Access Compliance Report

Public Rights-of-Way

(Curb Ramps)

Intersection ID: 53017	Main Street: STEEL_HOUSE_BV	Cross Street: CHARTRES_LN	Location: SE
ADA ID: E8826E40F6D3	Ramp Type: Perp	Initial Pass/Fail: Pass	Overall Compliance: No
Severity Score: 10			
Codes/Mitigation Info/Possible Solution		Field Measurements/Component Compliance

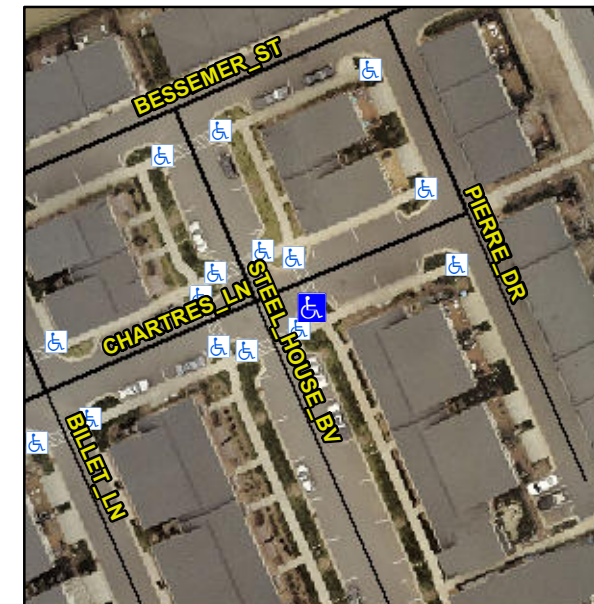
Not Found, R305.1.4, R305.2, R302.7.2

Compliance	Description	Data	Compliance	Description	Data
N/A	Ramp Length (in)	83.0	Yes	Ramp Slope (%)	7.6
Yes	Ramp Width (in)	61.5	Yes	Ramp XSlope (%)	0.4
N/A	Flare Type LT	None	N/A	Flare Type RT	N/A
N/A	Flare Slope LT (%)	N/A	N/A	Flare Slope RT (%)	N/A
N/A	Flare Traversable LT?	N/A	N/A	Flare Traversable RT?	N/A
Yes	Landing Length (in)	63.0	Yes	DWS Provided?	Yes
Yes	Landing Width (in)	59.0	Yes	DWS Contrast?	Yes
Yes	Landing Slope (%)	2.0	Yes	DWS Length (in)	24.0
Yes	Landing X Slope (%)	0.0	No	DWS Full Width?	No
N/A	Landing Curb? (Y/N)	No	No	DWS Offset (in)	5.0
N/A	Shared Landing?	No			
Yes	Gutter Ponding?	No	Yes	Gutter Slope (%)	4.9
No	Gutter Lip Ht (in)	0.5	Yes	Gutter X Slope (%)	0.5
N/A	Painted X Walk1?	No	N/A	Painted X Walk2?	N/A
	X Walk 1 Direction	To N		X Walk 2 Direction	N/A
N/A	X Walk 1 Width (in)	N/A	N/A	X Walk 2 Width (in)	N/A
	X Walk 1 Slope (%)	1.9		X Walk 2 Slope (%)	N/A
	X Walk 1 X Slope (%)	0.0		X Walk 2 X Slope (%)	N/A

N/A	Ramp inside XWalk1?	N/A	N/A	Ramp inside XWalk2?	N/A
	Road Slope (%)	N/A	N/A	Clear Space?	Yes
	Road X Slope (%)	N/A	N/A	Clear Space to XWalk (in)	N/A
Yes	Any Obstructions?	No	Yes	Storm Grate/Utility Hazard?	No
	Obstruction Type			Storm Grate/Utility Type	
		N/A			N/A
		Yes		Surface Condition? (G/P)	Good

Remove & Replace Entire Ramp.
